Additional SAS-1.1 Expander Issues

September 28, 2005

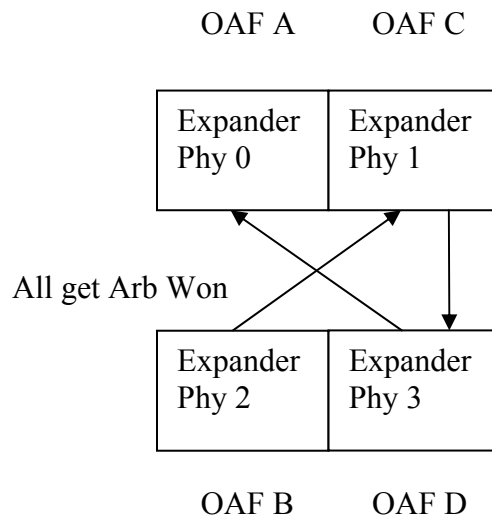
Expander Phys 0, 1, 2, and 3 receive open address frames (OAF) A, C, B, and D respectively, where by arbitration rules $D > C > B > A$. Oaf A received on expander phy 0 requests a connection to expander phy 2, Oaf C received on expander phy 1 requests a connection to expander phy 3. OAF B is destined for expander phy 1 and OAF D is destined for expander phy 0.

Example Summary:

OAF A received phy 0 destined for phy 2

OAF C received phy 1 destined for phy 3

OAF B received phy 2 destined for phy 1

OAF D received phy 3 destined for phy 0

Assuming there are sufficient routing resources and the connection rates are valid this scenario proves to be problematic. The expander function receives four request path messages from the respective expander phys. The value of phy status during this phase of the request path is such that Condition a) is satisfied for all ports. Condition b) is satisfied based on the assumption that the expander is designed accordingly. Condition c) rules out expander phy 0 to receive an Arb Won message since $OAF D > A$. Condition d) does not create any further restrictions since each OAF is destined to a unique expander phy.

Thus, since all conditions are met, an Arb Won message is issued to expander phy 3 with OAF D, expander phy 2 with OAF B, and expander phy 1 with OAF C. There are two error cases that need to be considered:

- 1) Expander phy 1 should not receive an Arb Won as it will cause a collision in the connection between expander phy 0 and 3
- 2) Expander phy 2 should not receive an Arb Won since OAF B sent to an end device attached to expander phy 1 will be ignored due to $C > B$. Further, expander phy 1 may have issued AIP due to receiving OAF C, which in turn could result in a hung connection attempt (i.e. an Open Timeout would not occur).

A recommendation to solve this problem is to add the following clause to the Arb Won qualification.

- e) the connection request of this expander phy is higher priority than an outstanding connection request of the destination expander phy.
